SERVICE INSTRUCTION MS 11/06E Rev B

Utfärdare Issued by Aussteller Jerry Johansson	Datum Date Datum 2006-12-01 Rev 2008-12-12	Produkt Product Produkt All hoists/lifts
Från maskin nr. From machine No. - Von Maschine Nr.	Till To - Zu	Berör/Concerns/Betrifft Safety devices

Expiry dates on safety devices

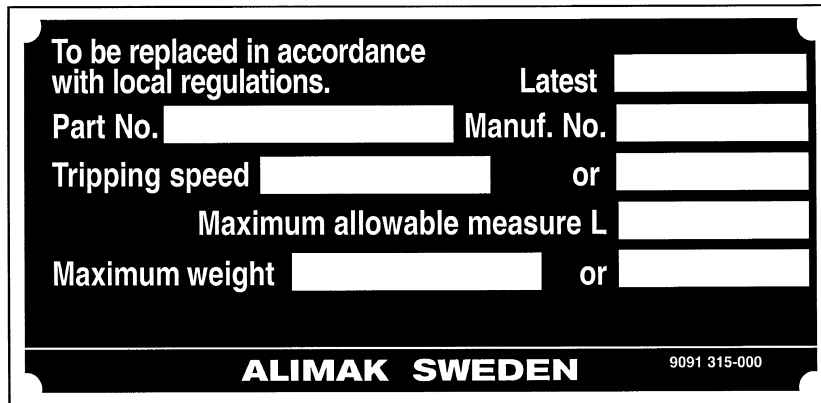
The sign on the safety device has been changed. The new design is shown below.

The certificate No., which is related to the safety device, will be engraved at the bottom of the sign. The same sign will be used for Ex-classified safety devices.

The expiry date will be five (5) years from the manufacturing date **or four (4) years from the first drop test, whichever comes first.**
